TECHNICAL SERVICE BULLETIN

Classification: BT23-014	Reference: NTB23-061	Date: August 21, 2023
-----------------------------	-------------------------	--------------------------

DELETION OF COWL TOP SIDE TRIM COVERS

APPLIED VEHICLES: 2024 Pathfinder (R53)

Figure 1

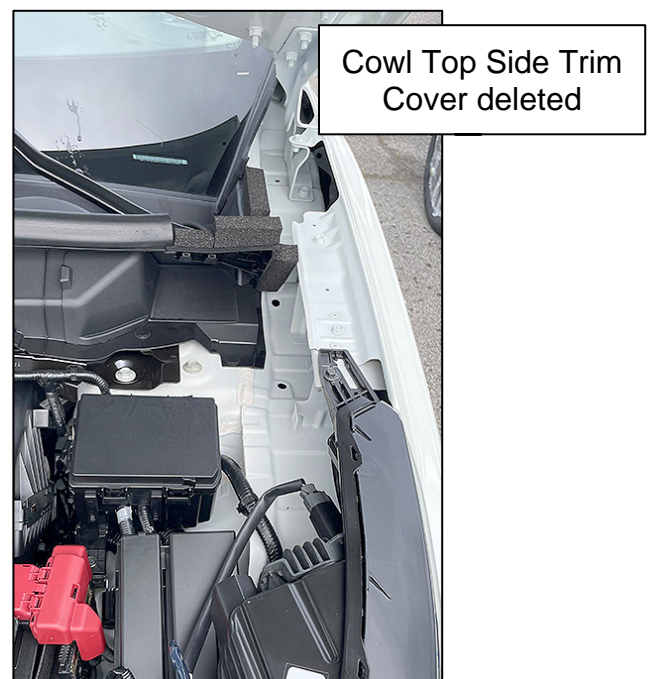
Both driver (LH) side and passenger (RH) side Cowl Top Side Trim Covers (Figure 1) have been deleted (Figure 2) from the **APPLIED VEHICLES** specifications and are no longer standard equipment. These parts are listed as the following in the EPC:

- FRONT FENDER DRIP, RH (part number 638E8-6TA0A)
- FRONT FENDER DRIP, LH (part number 638E9-6TA0A)

HINT: Figure 1 and Figure 2 are of the driver (LH) side Cowl Top Side Trim Cover. The passenger (RH) side Cowl Top Side Trim Cover is similar.

The replacement or addition of these non-standard equipment is not warrantable.
